VILLAGE OF ELM GROVE

BUILDING BOARD

Tuesday, March 1, 2016 * 5:30 PM * Park View Room

To: Building Board
From: Casey Griffiths, Zoning & Planning Administrator/ Asst. to the Village Manager
Date: February 25, 2016
Re: Review of Agenda for Tuesday – March 1, 2016

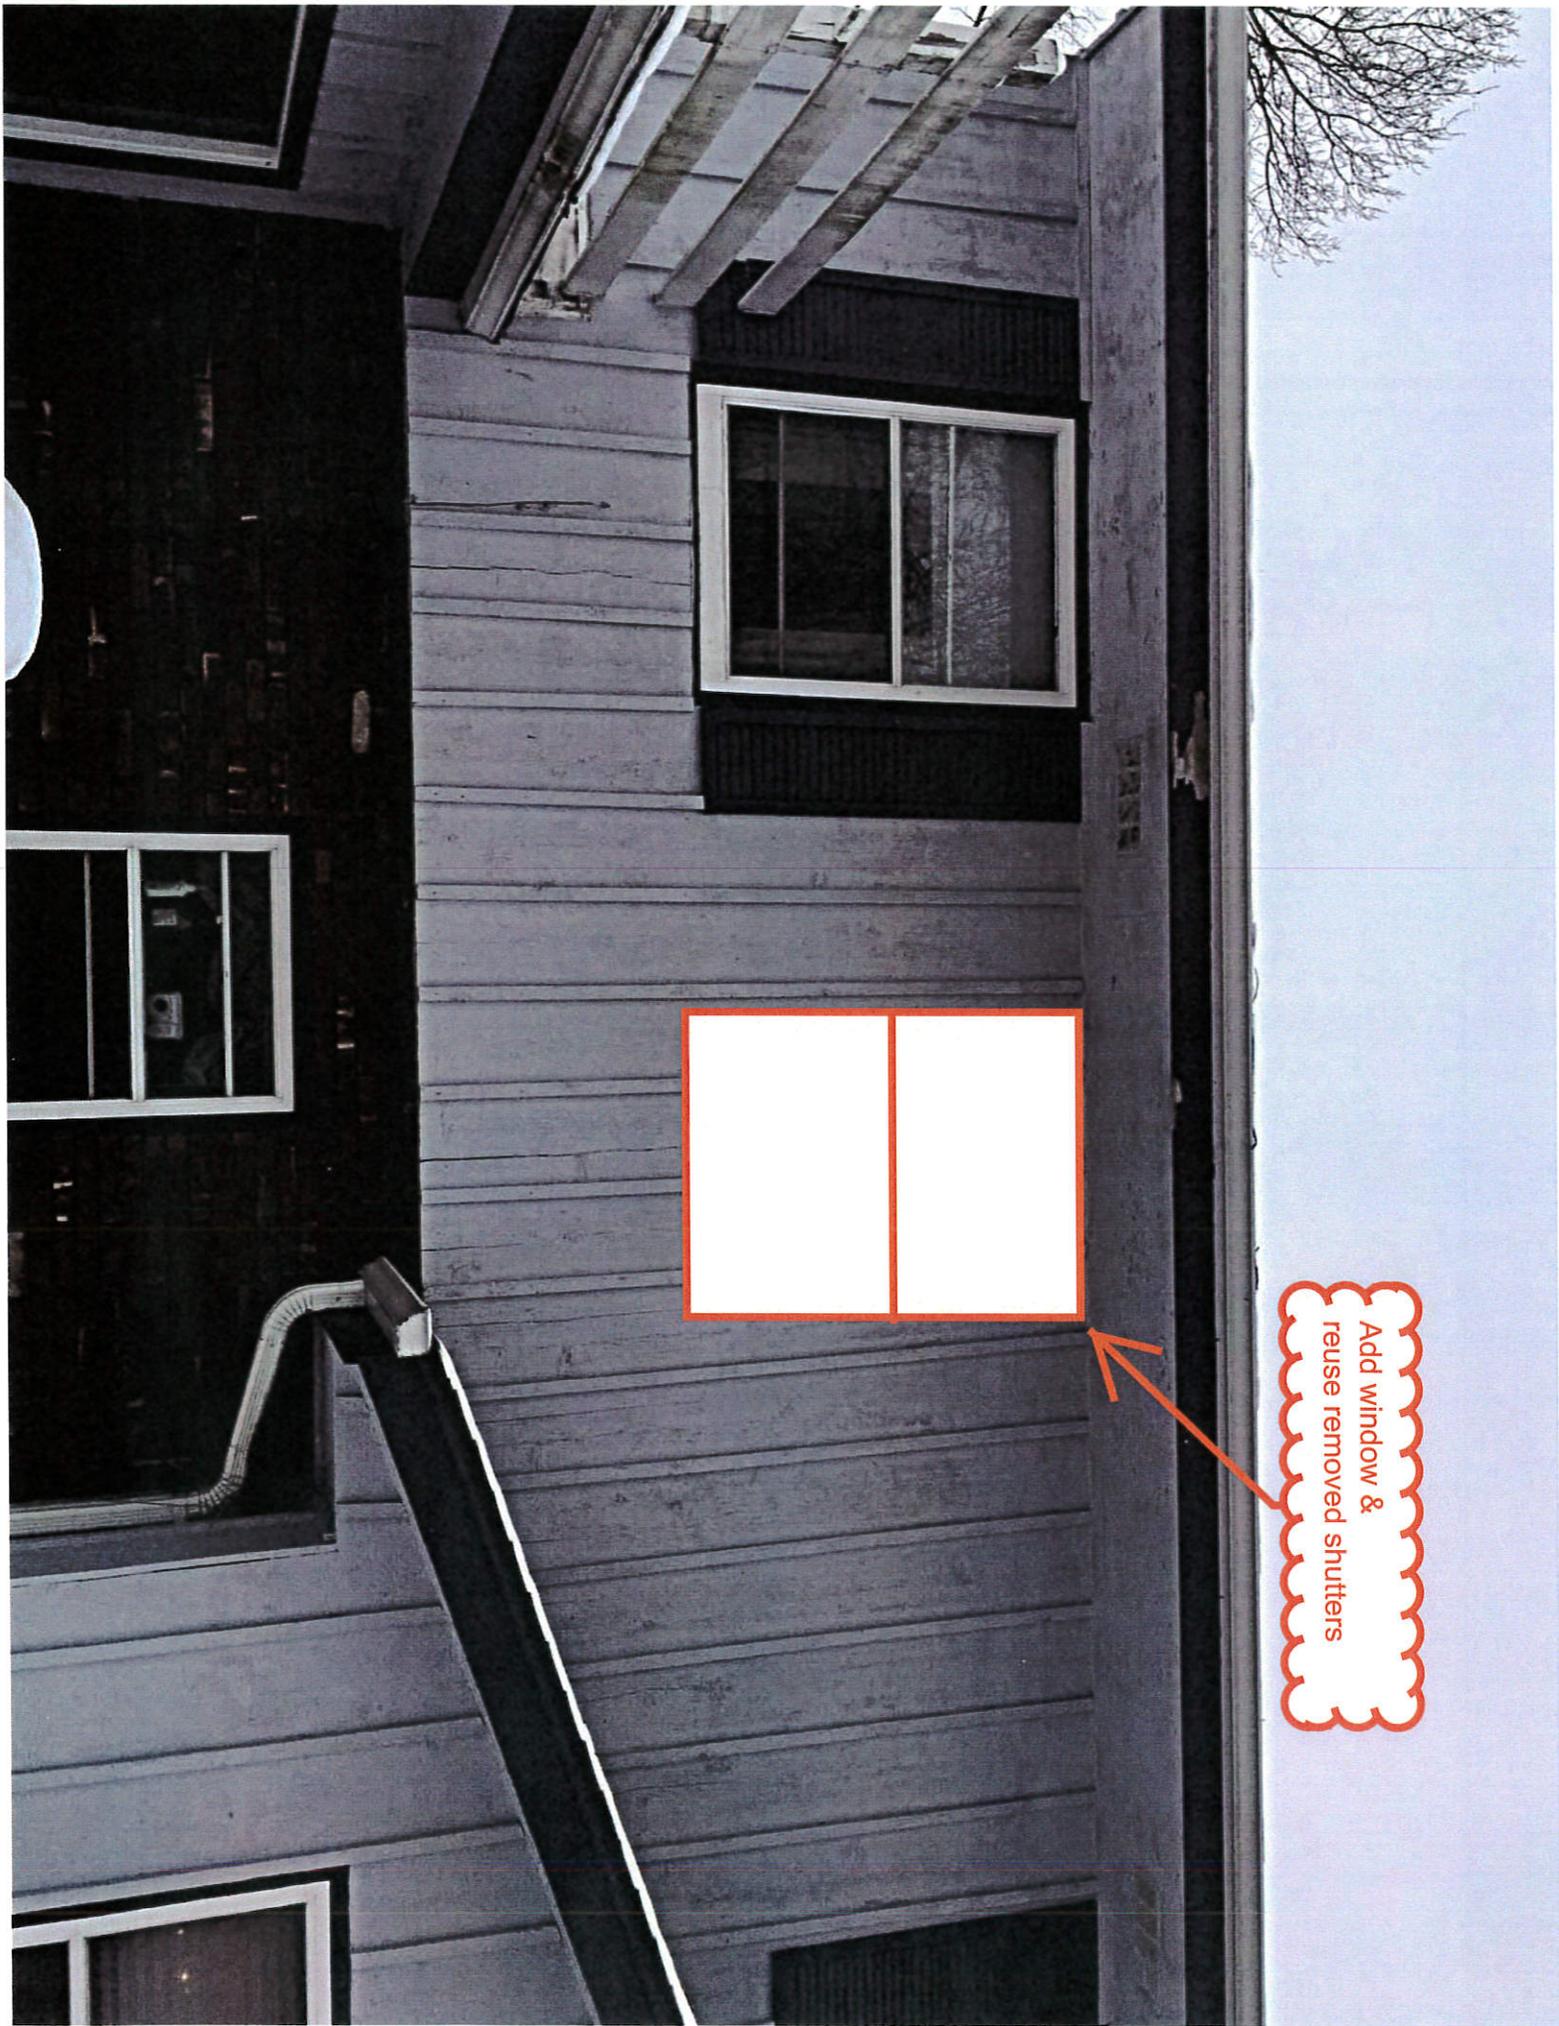
Remove added door & replace w/ matching siding

Remove window & replace w/ matching siding

Add window &
reuse removed shutters
